ENBRIDGE GAS INC.

First Tracks Consulting Service In. Answers to
Interrogatories from School Energy Coalition (OEB)

Exhibit I.7.EGI.SEC.1

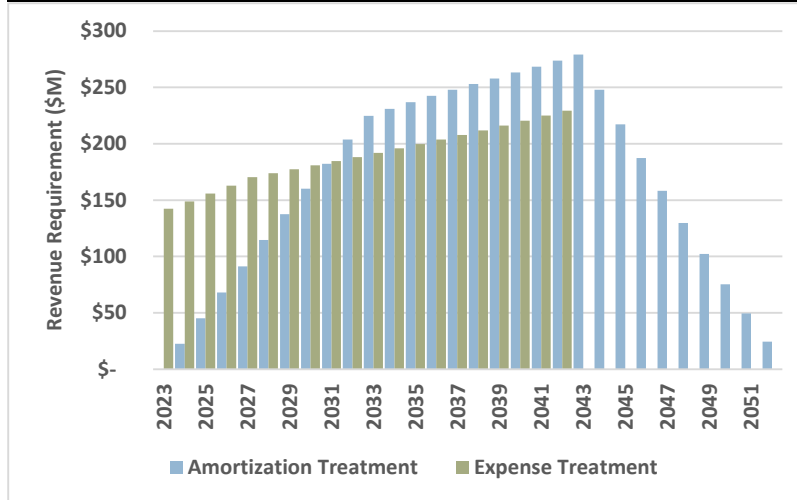
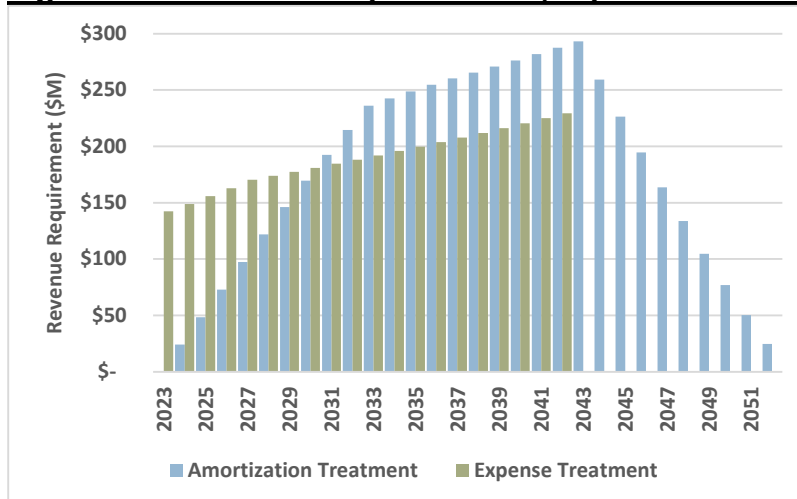
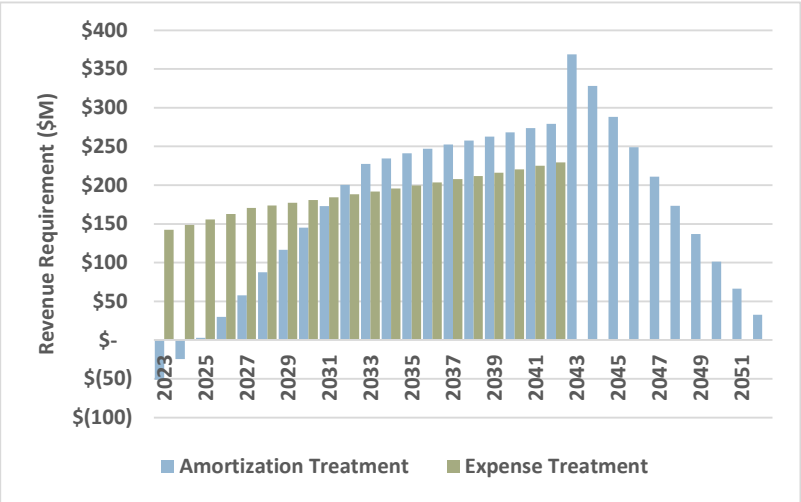
[Ex. Reply, p. 12] Please re-do Figures 3 to 6 taking into account the tax impacts, and provide a live Excel version of the results.

Three versions of Figures 3 and 5, which present revenue requirements, are provided below:

- Figure 3A/5A: original figures from my report, with no tax treatment in revenue requirement
- Figure 3B/5B: Including equity earnings grossed up for income taxes, and amortizing DSM expenditures for tax purposes
- Figure 3C/5C: Including equity earnings grossed up for income taxes, but treating DSM expenditures as expenses for tax purposes
